Addendum #1

Solicitation # 7449692

TITLE: A & E Services: Design of Biology Dept. Renovations @ CCRI

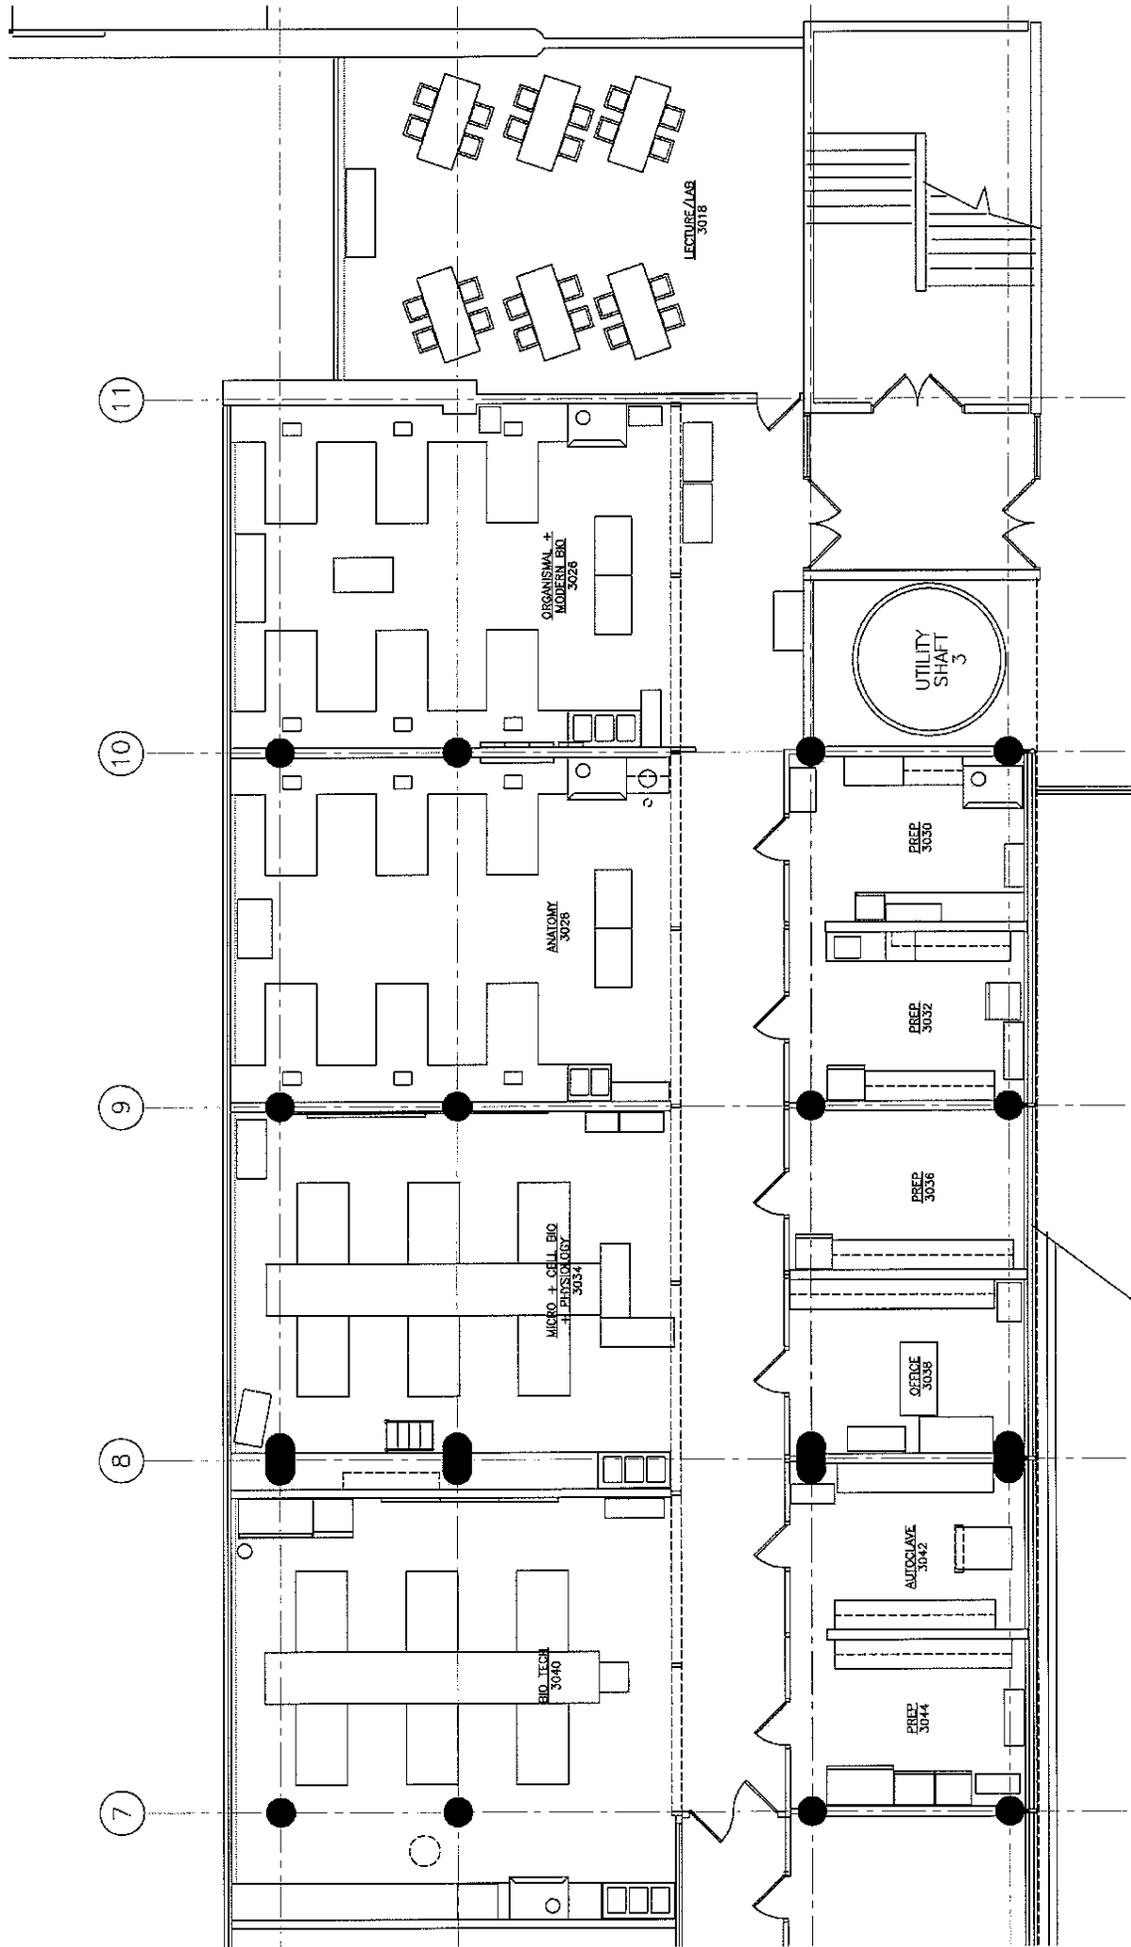
1. The solicitation feasibility study references an existing conditions plan and a proposed plan. May we have access to the referenced plans?

Answer: The existing conditions plan SK1 And the proposed plan SK 2 are released in this addendum. This represents two drawings
